# Access Compliance Report

## Public Rights-of-Way

### (Curb Ramps)

Intersection ID: 27806	Main Street: PARKS_FARM_LN	Cross Street: REA_RD	Location: NW
ADA ID: 40AA352BEA67	Ramp Type: PerpDiag	Initial Pass/Fail: Pass	Overall Compliance: No
		Severity Score: 0.25

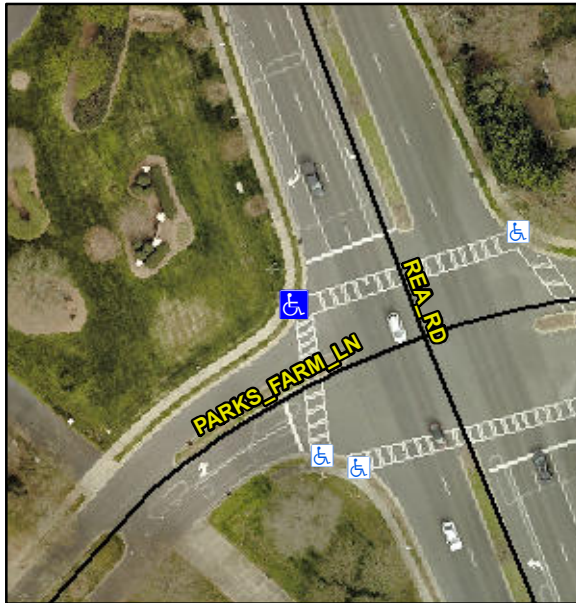
**Not Found, R304.2.1, R304.5.3**

Compliance	Description	Data	Compliance	Description	Data
N/A	Ramp Length (in)	96.0	Yes	Ramp Slope (%)	6.5
Yes	Ramp Width (in)	51.0	Yes	Ramp XSlope (%)	2.3
N/A	Flare Type LT	Sloped	N/A	Flare Type RT	N/A
N/A	Flare Slope LT (%)	5.6	Yes	Flare Slope RT (%)	9.0
N/A	Flare Traversable LT?	Yes	N/A	Flare Traversable RT?	Yes
No	Landing Length (in)	11.5	Yes	DWS Provided?	Yes
Yes	Landing Width (in)	51.0	Yes	DWS Contrast?	Yes
Yes	Landing Slope (%)	0.9	Yes	DWS Length (in)	24.5
No	Landing X Slope (%)	3.8	Yes	DWS Full Width?	Yes
N/A	Landing Curb? (Y/N)	No	Yes	DWS Offset (in)	1.0
N/A	Shared Landing?	No			
Yes	Gutter Ponding?	No	Yes	Gutter Slope (%)	1.0
Yes	Gutter Lip Ht (in)	0.0	Yes	Gutter X Slope (%)	2.4
N/A	Painted X Walk1?	Yes	N/A	Painted X Walk2?	Yes
	X Walk 1 Direction	To S		X Walk 2 Direction	To NE
N/A	X Walk 1 Width (in)	102.0	N/A	X Walk 2 Width (in)	108.0
	X Walk 1 Slope (%)	0.4		X Walk 2 Slope (%)	2.1
	X Walk 1 X Slope (%)	2.5		X Walk 2 X Slope (%)	1.1

**Remove & Replace Curb Ramp With Two New Directional Ramps or Equivalent.**
